APPEAL SUMMARY

Appeal ID: 23507	Project Address: 151 N Killingsworth St
Hearing Date: 2/26/20	Appellant Name: Justin Cammack
Case No.: B-014	Appellant Phone: 503-297-8791
Appeal Type: Building	Plans Examiner/Inspector: John Cooley, Corey Stanley
Project Type: commercial	Stories: 4 Occupancy: M, R-2, S-1 Construction Type: V-A, V-A, V-A
Building/Business Name: Koz Killingsworth LLC	Fire Sprinklers: Yes - Throughout
Appeal Involves: Erection of a new structure	LUR or Permit Application No.: 19-109551-CO
Plan Submitted Option: pdf [File 1] [File 2] [File 3] [File 4] [File 5]	Proposed use: Ground floor retail & living units, 3 upper floors living units

LIFE SAFETY CHECKSHEET

Street Address:	151 N KILLINGSWORTH ST					
Description of Work:	DEFERRED SUBMITTAL FOR FIREPROOFING					
The following assumptions were made when reviewing your project:						
Code Edition	Occupancy group	Construction Type	Building Area	Stories	Sprinklers	Alarms
2014 OSSC	M / R-2 / S-1	V-A V-A V-A	SF	4	Yes

Section Detailing SFRM at WF Beam

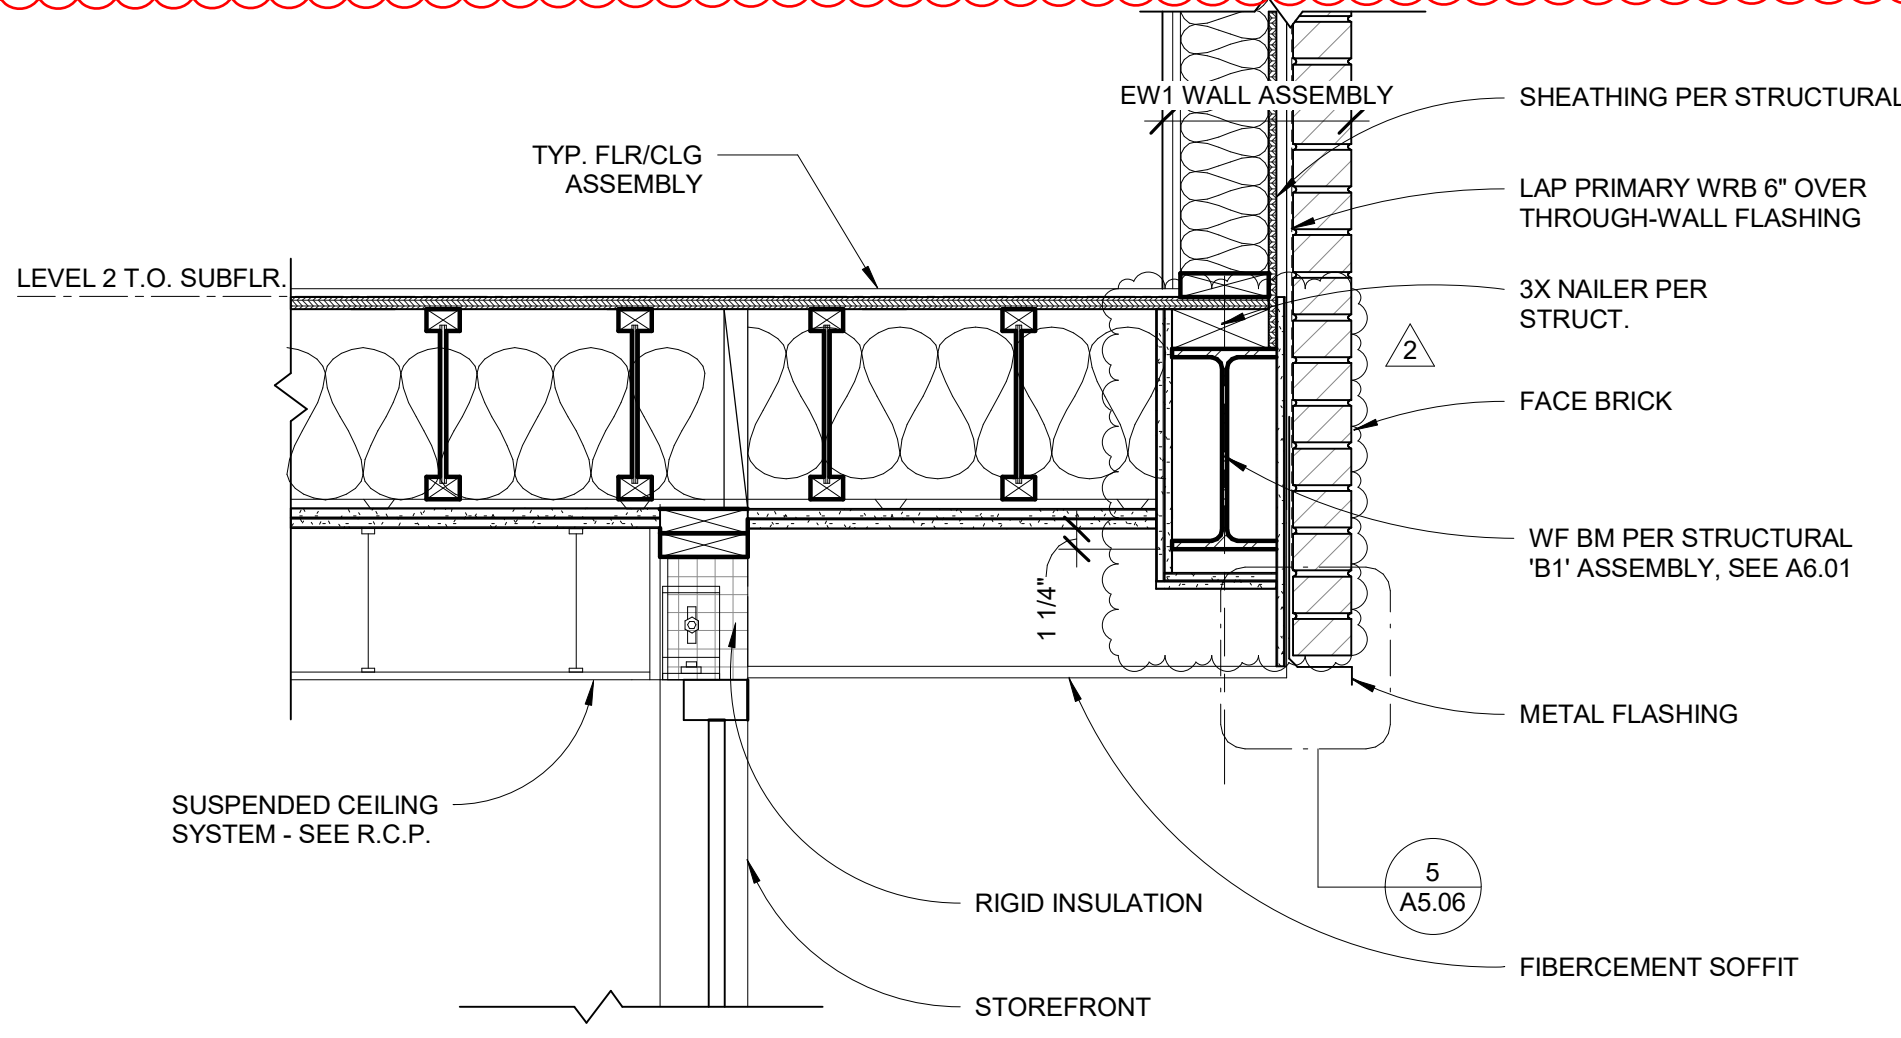
Code Section	703.2
Requires	Fire protection of structural beams utilizing standard spray applied fireproofing.
Code Modification or Alternate Requested	Requesting approval to use UL column design for wide flange beams when supporting a rated wood floor assembly.
Proposed Design	The use of column design thicknesses for wide flange beams. See attached letter and engineering judgement for more information.
Reason for alternative	There exists no UL design for fireproofing structural steel beams within wood construction as such we propose to utilize the column design which is based on a more stringent 4-side exposure.

Alternate fire rated beam assembly with engineering analysis: Hold for additional information.
Appellant may contact John Butler (503 823-7339) with questions.
